Office Action Summary	Application No. 10/596,676	Applicant(s) MULCH ET AL.	
	Examiner David J. Laux	Art Unit 3743

DETAILED ACTION

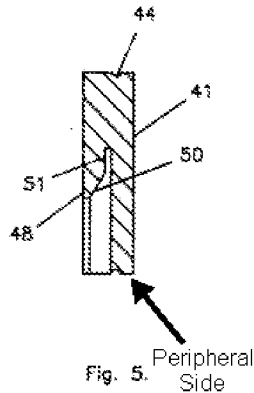
6. '801 discloses a heat protection body (40) for a protection system for a furnace inner wall (Abstract), the heat protection body (40) having a front side (41), an opposing rear side (42), and peripheral sides (43) extending therebetween, with a groove (46) extending inwardly from the rear side (42) and one of the peripheral sides (43) (Figs. 4 & 5), wherein the cross-sectional area of the groove (46) continuously decreases as the groove extends inwardly from the one of the peripheral sides (See Fig. 5 reproduced

below; at location point labeled 50, the cross-sectional area of the groove continuously decreases as the groove extends inwardly from the peripheral side).

9. With regard to claim 16, '801 further discloses the thickness of the heat protection body (40) between the groove (46) and the rear side (42) increases as the groove extends inwardly from the one of the peripheral sides (Fig. 5 at portion marked 50).

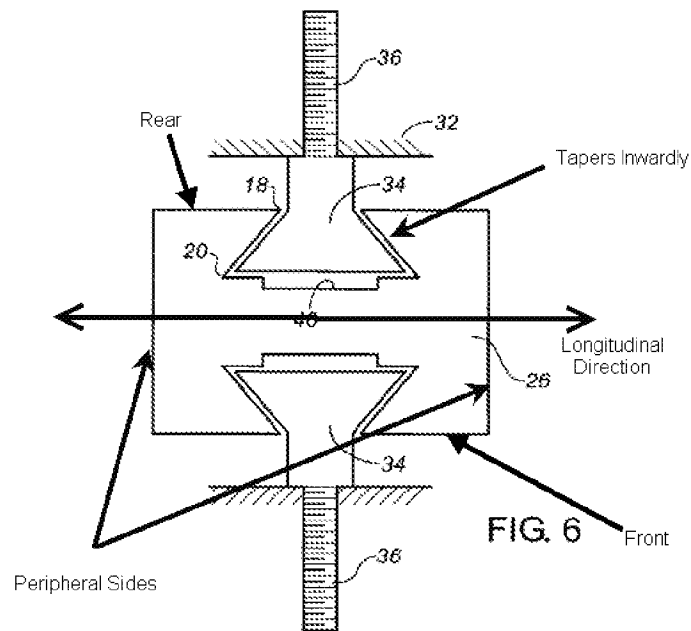
13. '801 fails to disclose and wherein the groove cross-section tapers in the longitudinal direction of the groove inwardly from the peripheral side. '905 teaches a groove cross-section that tapers in the longitudinal direction of the groove inwardly from the peripheral side (see Fig. 6 reproduced below). It would have been obvious for one skilled in the art at the time of invention to combine the heat protection body of '801 with the trapezoidal cross-section of the hanger and slot of '905 because such a combination would have produced the added benefit of a uniformly distributed stress load along the upper portion of the hanger and slot which would reduce the likelihood of fracture of the hanger or slot from occurring.

17. With regard to claim 5, '801 as combined with '905 further discloses the groove cross-section broadening constantly from the rear side in the direction of the front side (See '905: Fig. 6 reproduced above).
